Re: Dunkin' Restaurant and Drive Through
970 Ashley Boulevard
New Bedford, MA

On behalf of the Applicant, Yearly Grind II, LLC, I offer the following as well as the attached revised site plans in response to the comments and feedback that we have received from the Board as well as members of the public during the on February 13th Public Hearing. The Applicant has revised the site, landscape and lighting plans in response to comments and feedback received regarding site circulation and access, residential screening, loading and deliveries. Below is a list of plan revisions that have been incorporated.

SHEET TITLE:
LANDSCAPE PLAN

Audible Exhibit

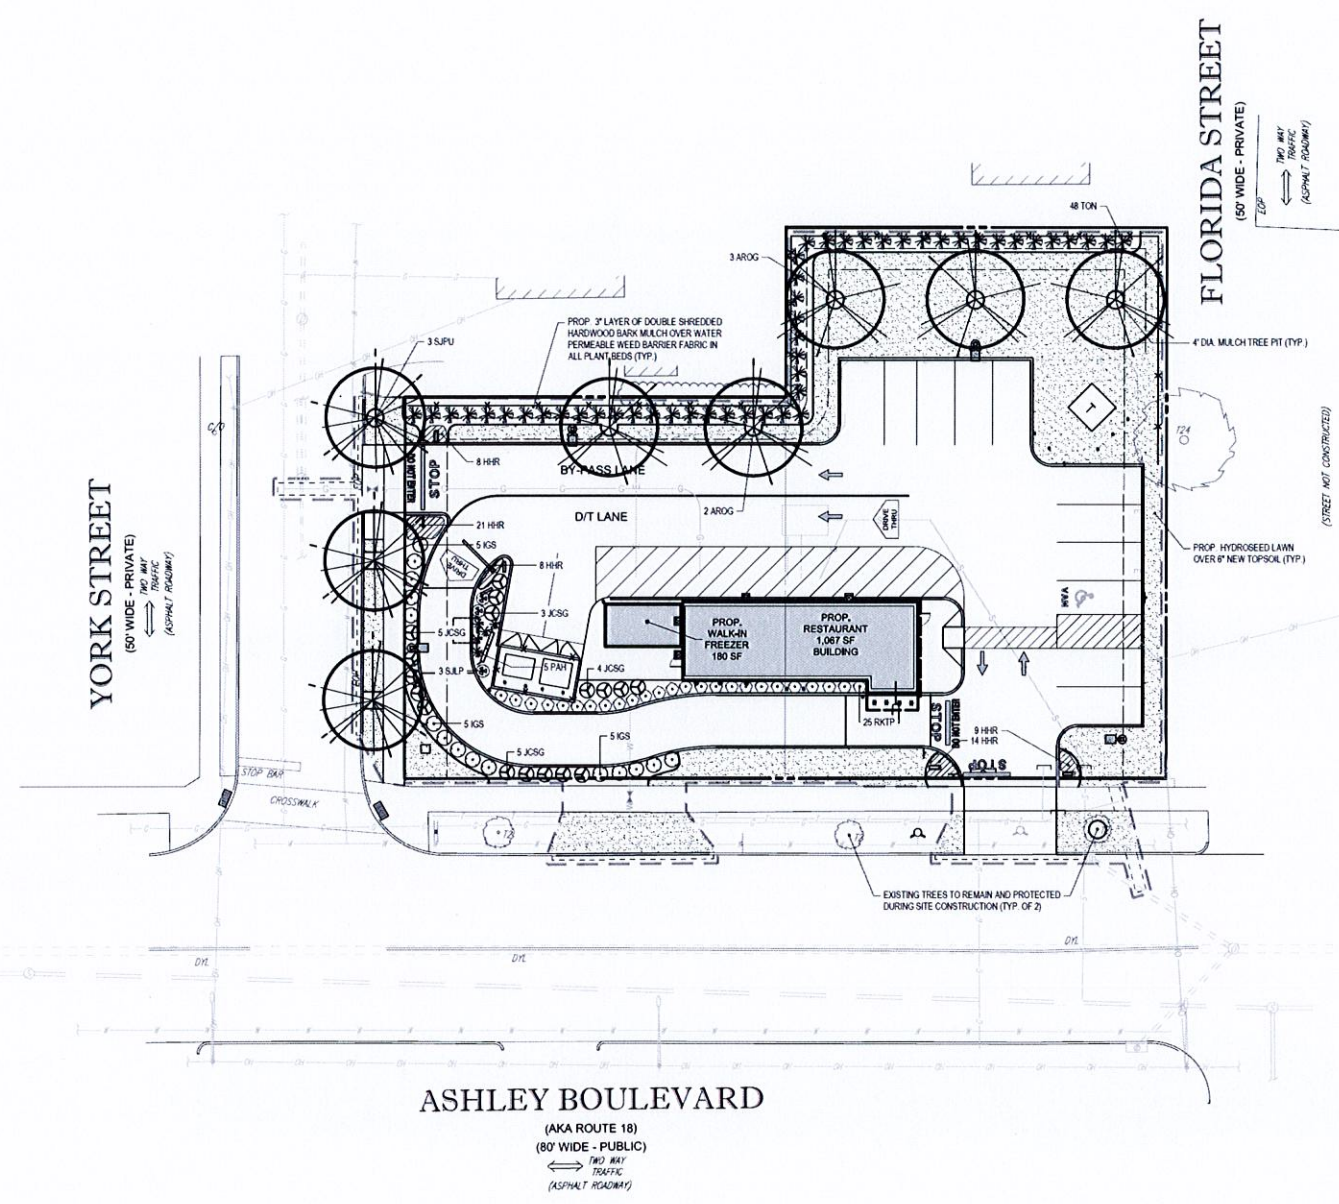
- Provided to show sound levels of the speaker system of the drive through.
- 65 decibels at 4 from speaker (per manufacture), with a rate of sound dissipation of 6 decibels every time distance is doubled.
- At 24 feet from speaker, Decibel reading of 50 is expected which is consistent with the ambient sound of an average residence.
- It is noted that screens, vegetation, fences and the like, will further muffle sound intensities.
